September 18, 2007  
Subject: **Milbridge**  
Project No's BR-1006(700)X & STP-  
01006(800)X  
Pin No's 010067.00 & 010068.00  
**Amendment No. 2**

STATE OF MAINE  
DEPARTMENT OF TRANSPORTATION  
**GREAT SOUTH AND GREAT NORTH BRIDGE**  
OVER  
NARRAGANSETT RIVER  
IN THE TOWN OF  
MILBRIDGE  
**SUPERSTRUCTURE DETAILS**

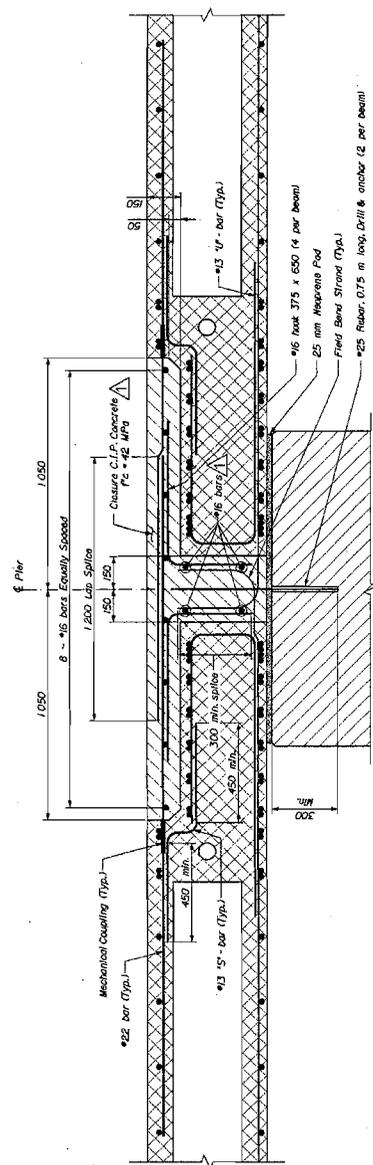
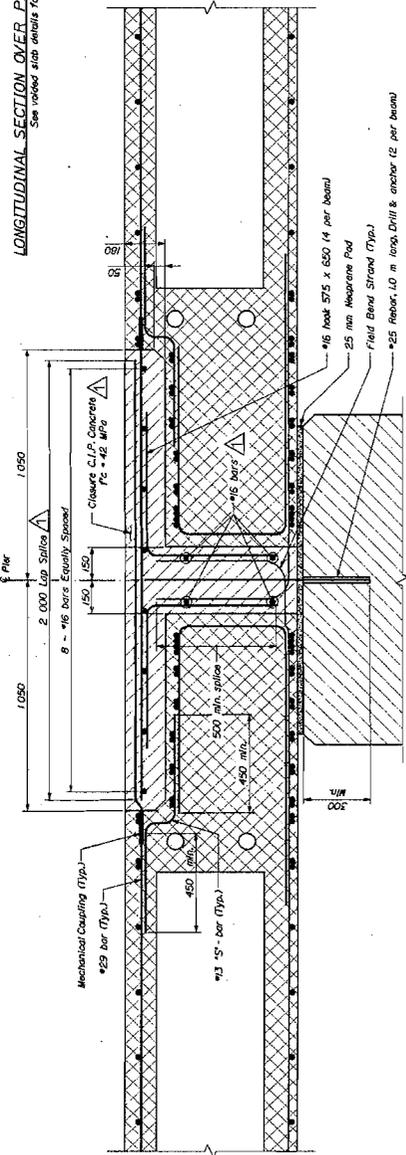
REMOVE the existing plan sheet forty-two of forty-four titled: “Superstructure Details” and REPLACE with the attached updated: “Superstructure Details” plan sheet, dated September 12, 2007.

**Question:** “Specify the 4 transverse bars shown either side of #25 pier anchor bars on both sections Sheet 42. Assume #16.”

**Question:** "I can see problems arising from trying to install a mechanical coupler between the #29 bars over the pier. Can a lap splice be used instead (like on the voided slabs)?"

**Response:** Yes, the above noted bars are #16’s. See change earlier in this amendment replacing plan sheet #42. The transverse #16 bars identified in the updated plan sheet shall be full length fascia to fascia less 50mm cover at each end. Note that the updated sheet also increases the closure placement’s required concrete strength and provides a practical lap splice length for Great North Bridge.

**Response:** Refer to the attached plan sheet #42 replaced earlier in this amendment. The concrete strength and reinforcement splice details at the pier closure concrete placements have been changed to allow for lap splices at Great North Bridge similar to Great South Bridge.
